GULF STATES UTILITIES COMPANY

February 17, 1984

River Bend Station - Units 1 & 2
Docket Nos. 50-458/50/459

Enclosed are Gulf States Utilities Company's (GSU) responses to the informal questions raised by reviewers from the Licensee Qualification Branch (LQB-RIV) based upon their review of the December 2, 1983 docketed letter from Mr. Booker to Mr. Denton. As a result of meetings between GSU and LQB-RIV on January 6, 1984, further clarifications with regard to the Final Safety Analysis Report (FSAR), Chapter 13, were necessary to complete input to the Safety Evaluation Report (SER). Attachment 1 summarizes these clarifications and references where the response is provided. Enclosure 1 provides the changes to the FSAR which will be included in the next amendment.

Figure 13.1-1a
Corporate Structure
Gulf States Utilities Company

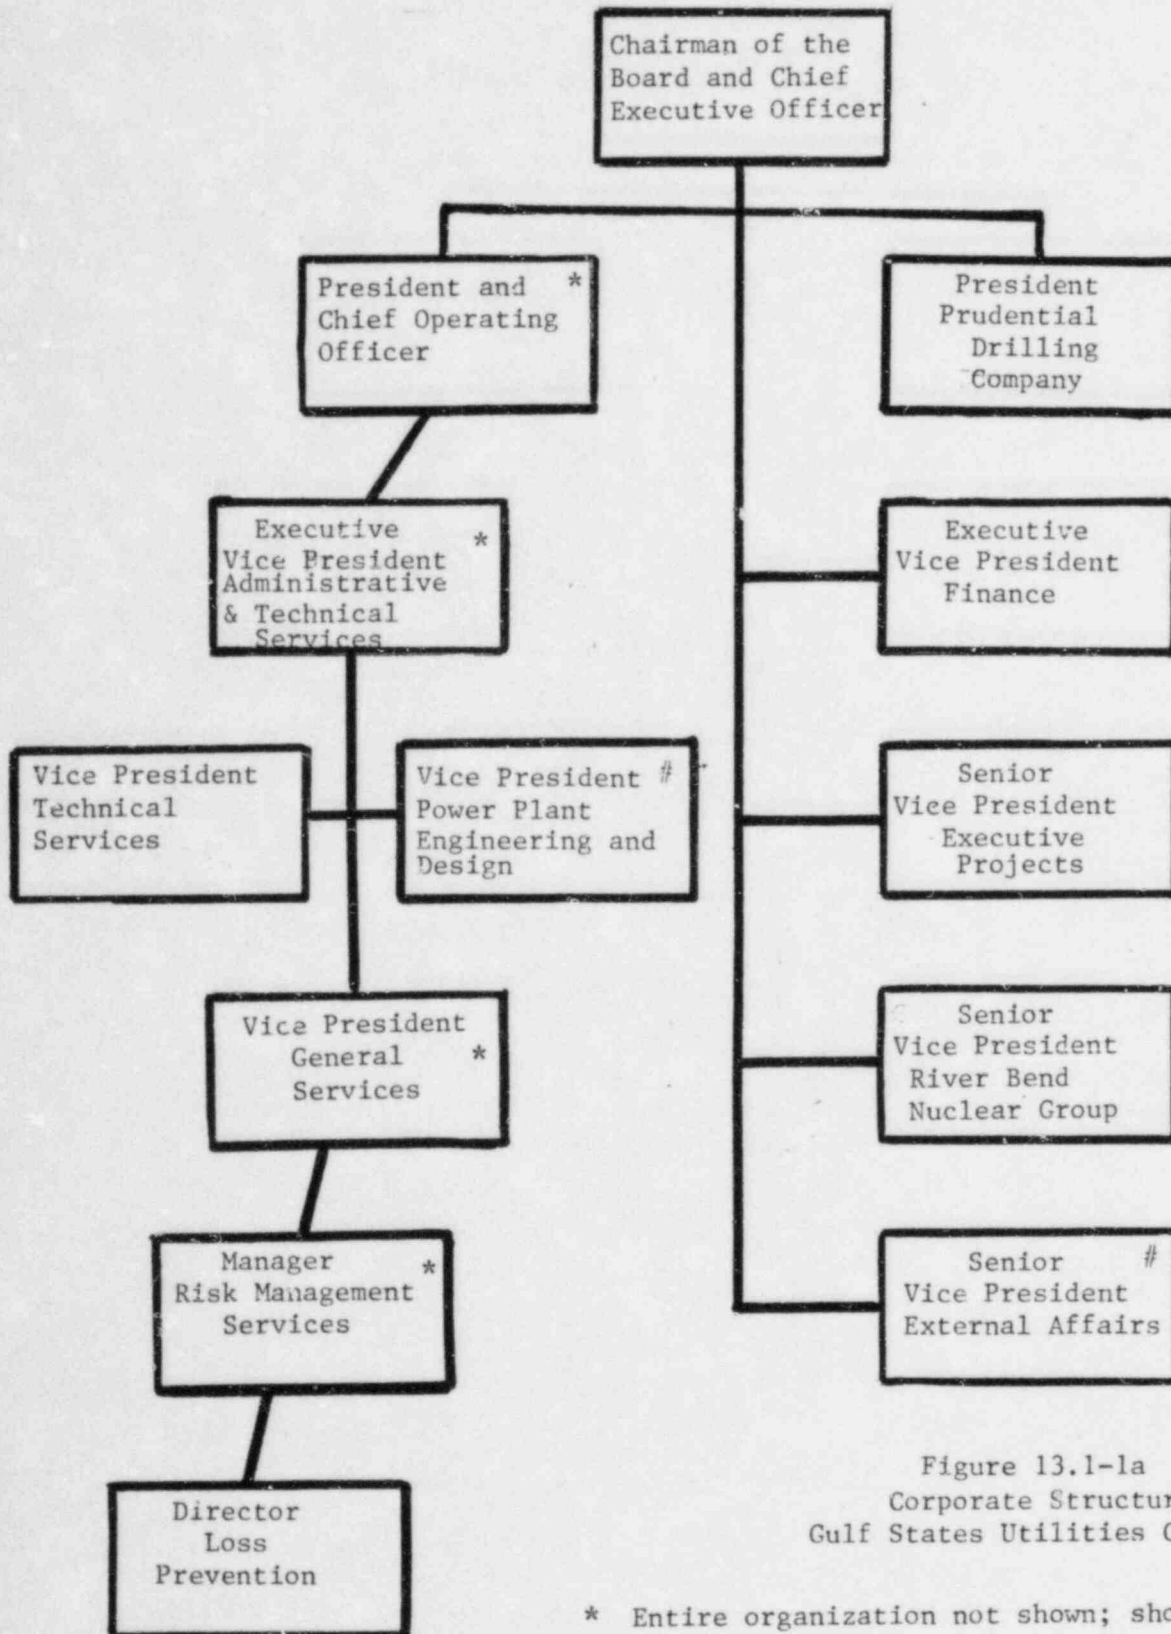
The Staff requested a sufficiently detailed description of the corporate organization to understand the position of individuals and organizations which interface with or provide technical support for the nuclear group.

See revised Section 13.1.1.1.3 and Figure 13.1-1a.

FIGURE 13.1-2

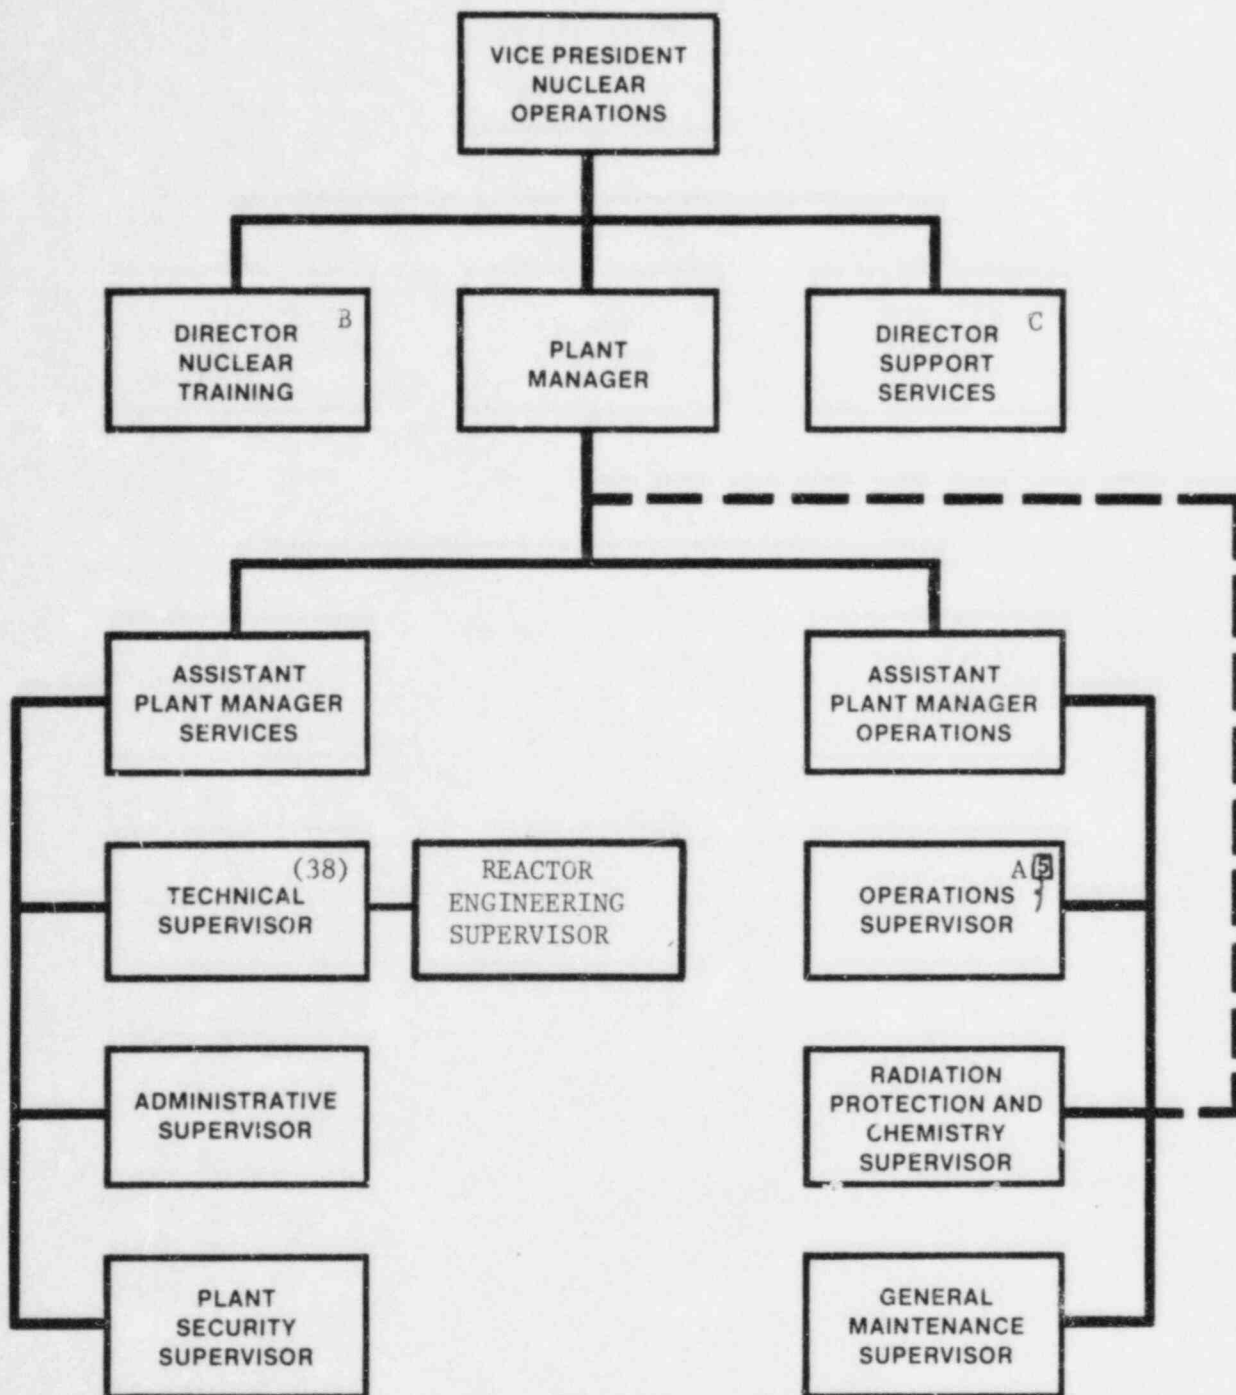
QUESTION 260.1 (17.2)

Revised Fig. 13.1-2 identifies the organizational elements of GSU as either "onsite" or "offsite." A description of their responsibilities is provided in Sections 13.1 and 17.2.1.

Figure 13.1-2a
Plant Operations Structure
Administrative Services Section
River Bend Station-Unit 1

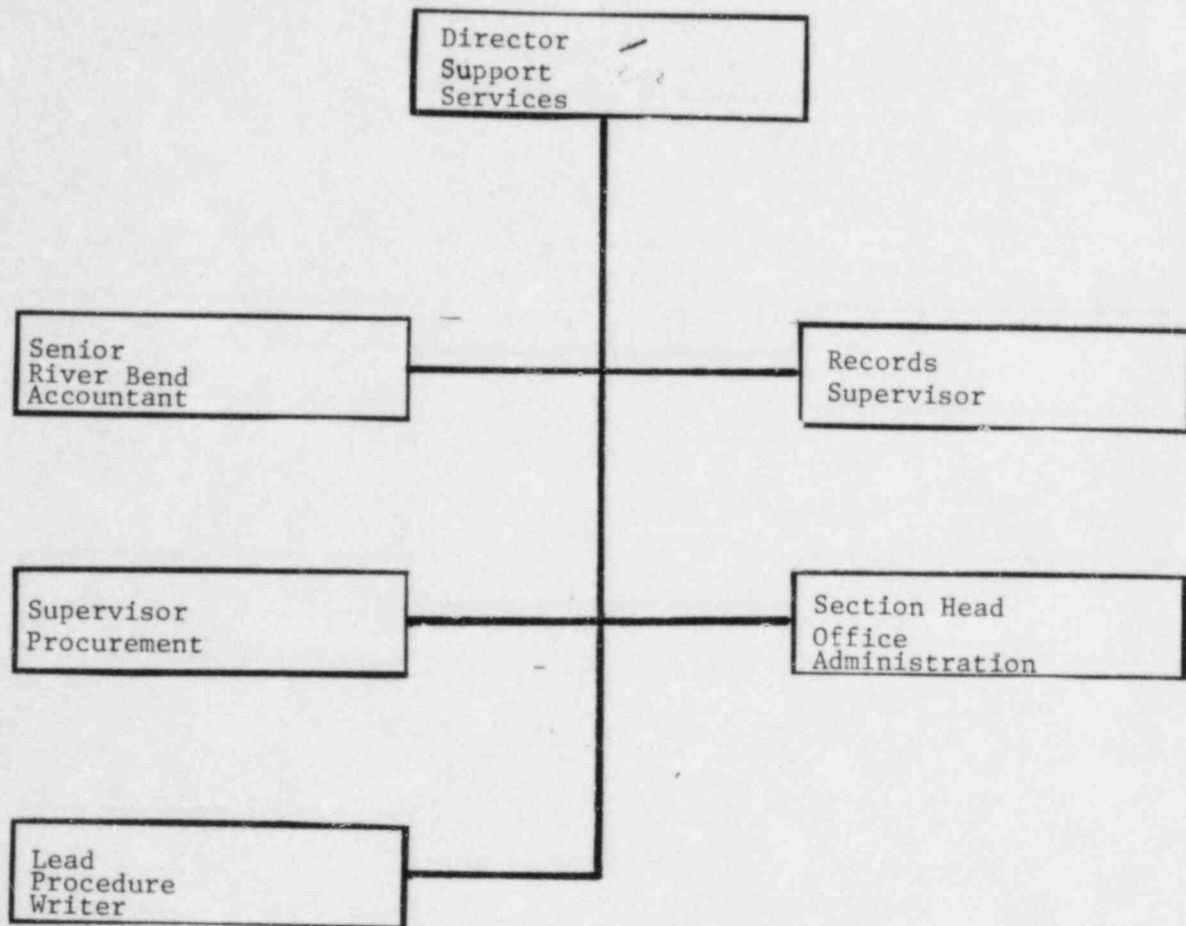
The Staff requested FSAR organizational charts and text to fully described the Nuclear Operations organization, including the Training Staff's size and minimum qualifications.

See revised Section 13.1.1.2.1.3 and Figures 13.1-2a and 13.1-2b for descriptions of the Nuclear Operations organization; the Training Staff's minimum qualifications will be addressed in a future submittal.
